Addendum 28 - Regulation No. 29

Revision 1 - Amendment 3

Supplement 2 to the 02 series of amendments – Date of entry into force: 13 February 2014

Uniform provisions concerning the approval of vehicles with regard to the protection of the occupants of the cab of a commercial vehicle

Appendix 2,

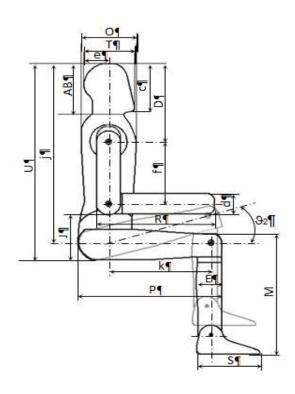
The figure, amend to read:

The table, amend to read:			
п			
Dimensions:			cm
	θ_1 Lateral rotation of the legs	20°	
	θ_2 Upward rotation of the legs	45°
